**Notice of Allowability**

10/064,960

### EXAMINER'S AMENDMENT

Fig. 2

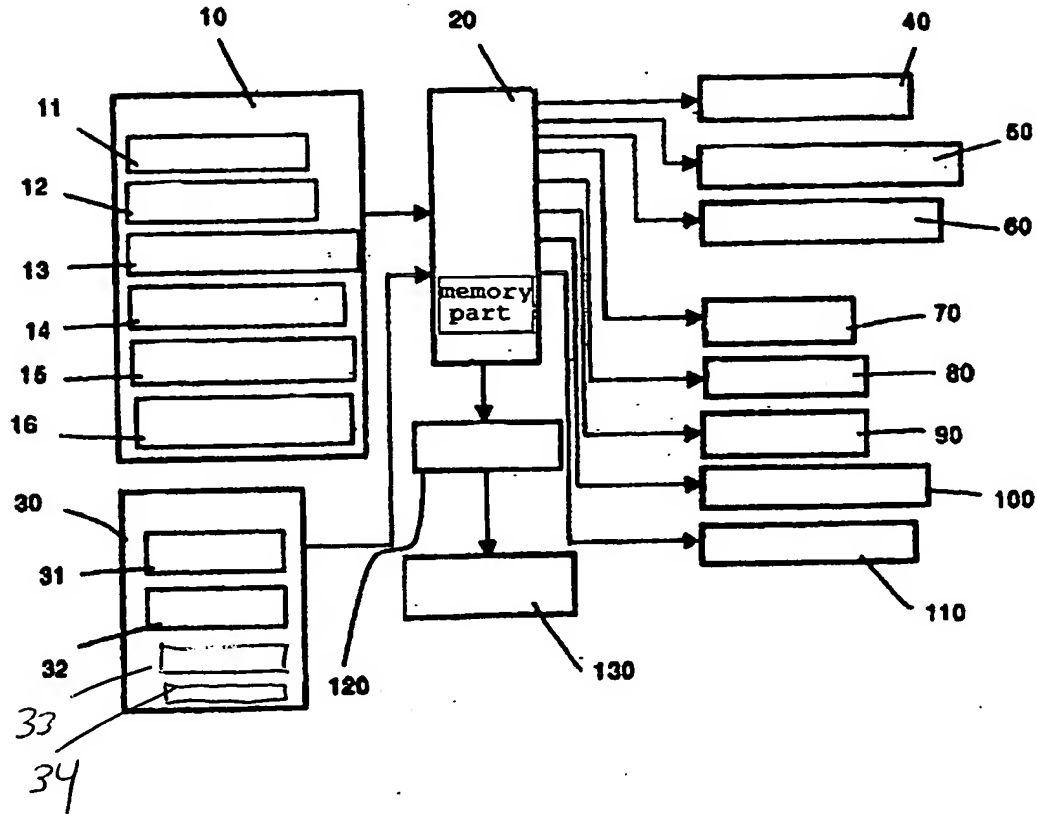
*Proposed drawing amendment, [mark-up of Fig. 2]*  
*LVC*  
*10-31-05*

3. The drawings were received on August 16, 2005. These drawings are hereby disapproved because the line quality is poor and also because an amendment to the drawings is required as noted in greater detail below.

4. The following changes to the drawings have been approved by the examiner and agreed upon by applicant: each of a heater driving choice key and a odor emitting device driving choice key must be shown schematically in setting section 30 in Figure 2 and labeled using reference numbers 33 and 34, respectively, as shown in the attached marked-up copy of Figure 2. In order to avoid abandonment of the application, applicant must make these above agreed upon drawing changes.

--Further, the setting section is provided with a heater driving choice key 33 for preventing pipes from being frozen and from bursting, as well as with an odor emitting device driving choice key 34 for generating an odor inside of the building.--
